CHANGE }  
No. 1 }

HEADQUARTERS  
DEPARTMENT OF THE ARMY  
WASHINGTON, DC, 8 January 1982

**Organizational Maintenance Manual  
CRANE-SHOVEL, TRUCK MOUNTED; 3/4 CUBIC YARD;  
20 TON; WITH CLAMSHELL, DRAGLINE, AND BACKHOE  
ATTACHMENTS; G.E.D. (HARNISCHFEGER CORP MODEL M320T2)  
NSN 3810-00-151-4431**

TM 5-3810-294-20, 5 April 1974, is changed as follows:

Figure 2-105.1. Adjusting front and rear drum brakes.

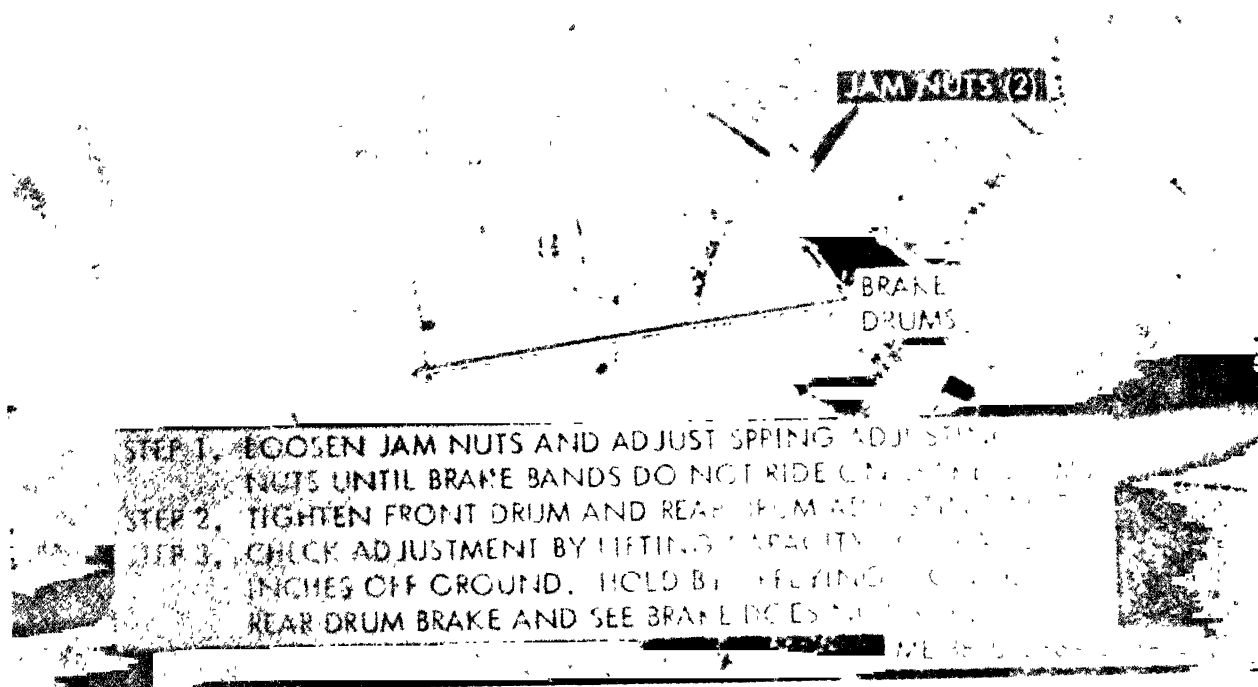
Figures 2-105.1 and 2-105.2 are added as follows.

Figure 2-107. Adjusting front and rear drum clutch.

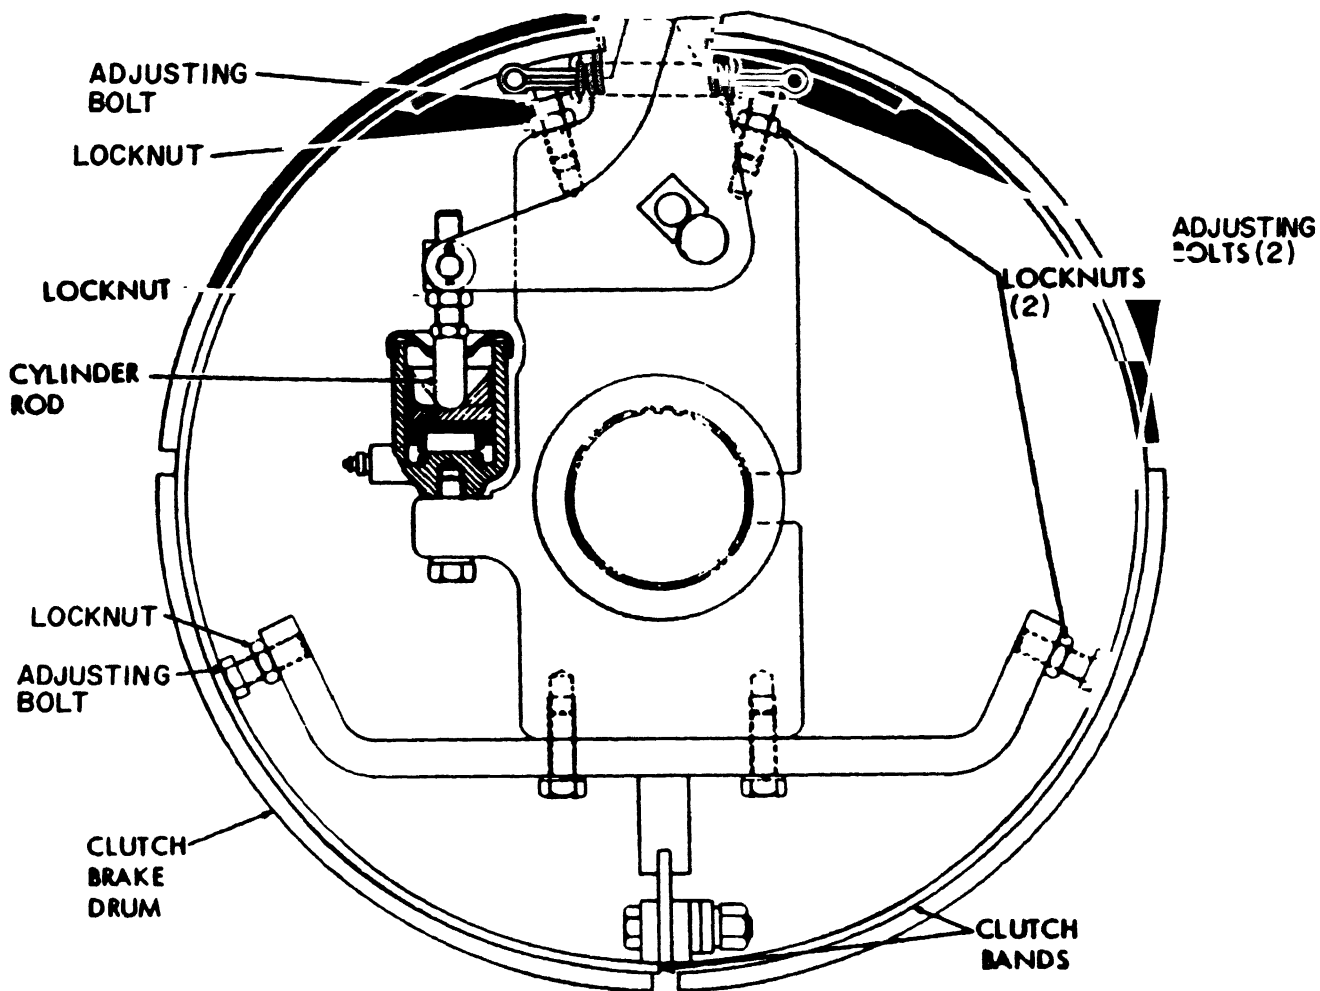
Page 2-114, figure 2-107 is superseded as follows.

- STEP 1. LOOSEN LOCKNUTS (4) WHICH SECURE ADJUSTING BOLTS (4).
- STEP 2. TURN ADJUSTING BOLTS OUT OF CONTACT WITH CLUTCH BANDS. CLUTCH BANDS MUST BE CENTERED IN CLUTCH DRUM. USE ADJUSTING BOLTS (4) AND A FEELER GAGE TO CENTER CLUTCH BANDS. TIGHTEN LOCKNUTS.
- STEP 3. LOOSEN LOCKNUT ON CYLINDER ROD.
- STEP 4. TURN CYLINDER ROD OUT UNTIL A PULL OF 15 TO 20 POUNDS ON A SPRING SCALE IS NEED TO ENGAGE THE CLUTCH. TIGHTEN LOCKNUT.

NOTE: ONLY STEPS 3 AND 4 ABOVE ARE NECESSARY TO ADJUST FOR LINING WEAR. USE COMPLETE PROCEDURE ONLY WHEN CLUTCH HAS BEEN REMOVED AND REPLACED.
